**AMENDMENT OF SOLICITATION/MODIFICATION OF CONTRACT**

2. AMENDMENT/MODIFICATION NO.  
A000053. EFFECTIVE DATE  
10-12-20154. REQUISITION/PURCHASE REQ. NO.  
675-16-1-3252-00015. PROJECT NO.(If applicable)  
615-14-150

VA248-15-R-2022

The purpose of this amendment is to: (1) Provide the following new or revised specifications;

### REVISED PORTION OF PL201 Addendum No.1

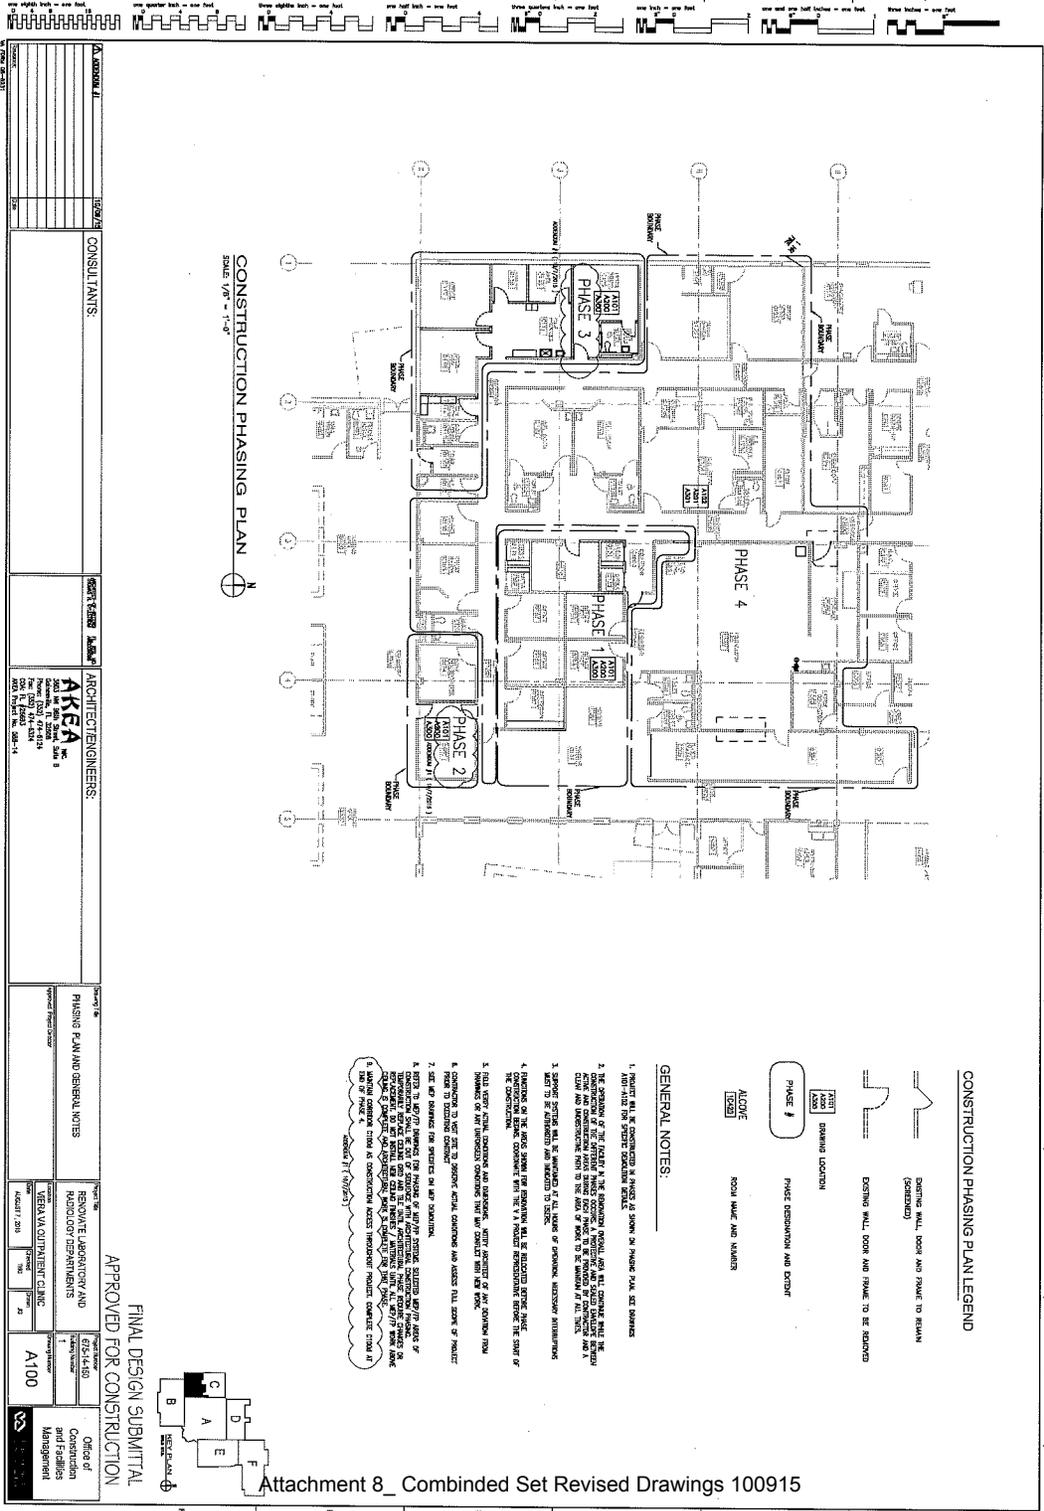
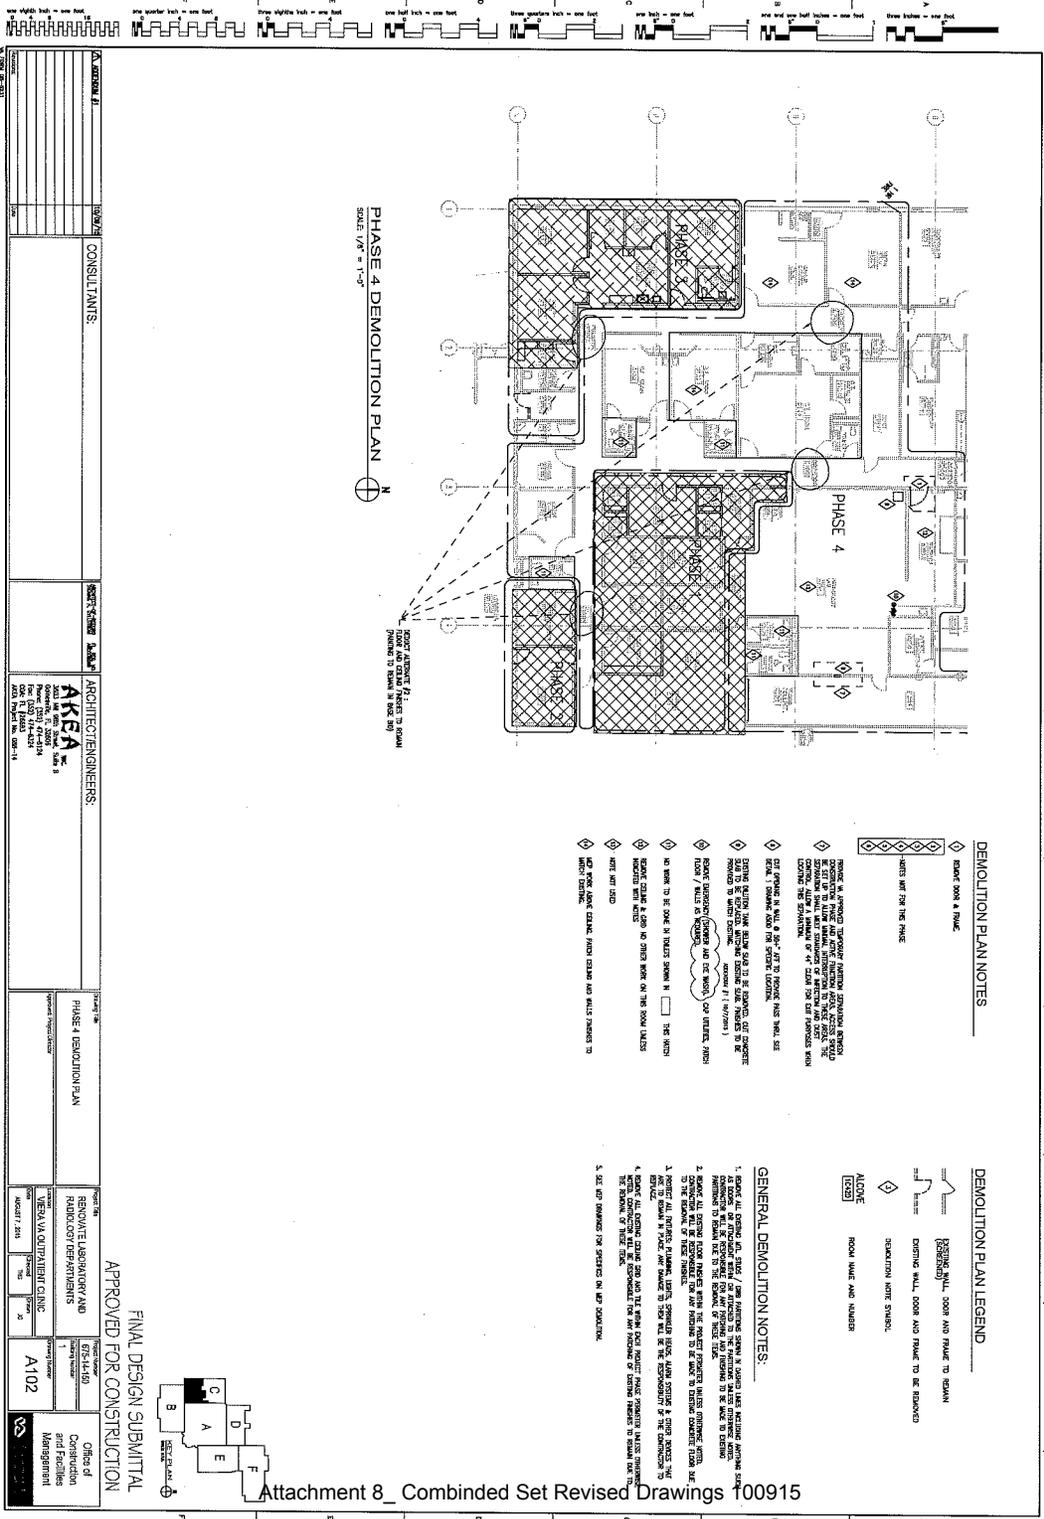
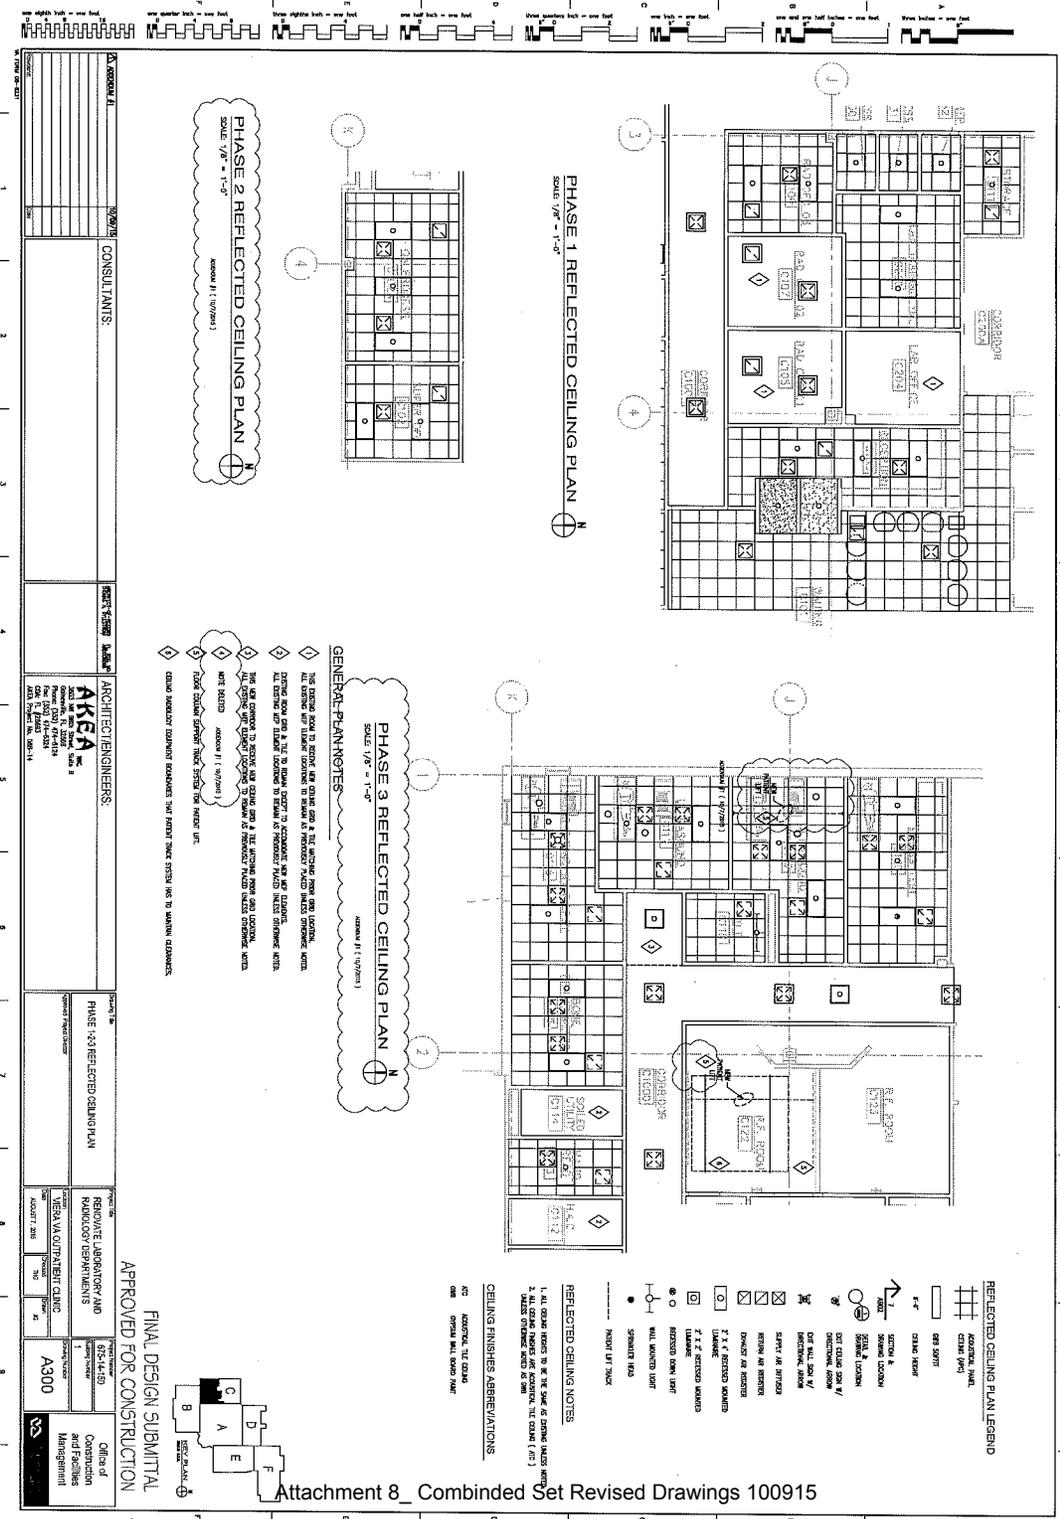
1. PHASE 1 WILL BE COMPLETED IN PHASE 2 AS SHOWN IN PHASE PLAN SET DRAWINGS.
2. ALL WALLS FOR PHASE 1 SHALL BE CONSTRUCTED IN PHASE 2.
3. THE REMOVAL OF THE EXISTING WALLS SHALL BE COMPLETED IN PHASE 2.
4. THE REMOVAL OF THE EXISTING WALLS SHALL BE COMPLETED IN PHASE 2.
5. THE REMOVAL OF THE EXISTING WALLS SHALL BE COMPLETED IN PHASE 2.
6. THE REMOVAL OF THE EXISTING WALLS SHALL BE COMPLETED IN PHASE 2.
7. THE REMOVAL OF THE EXISTING WALLS SHALL BE COMPLETED IN PHASE 2.
8. THE REMOVAL OF THE EXISTING WALLS SHALL BE COMPLETED IN PHASE 2.
9. THE REMOVAL OF THE EXISTING WALLS SHALL BE COMPLETED IN PHASE 2.
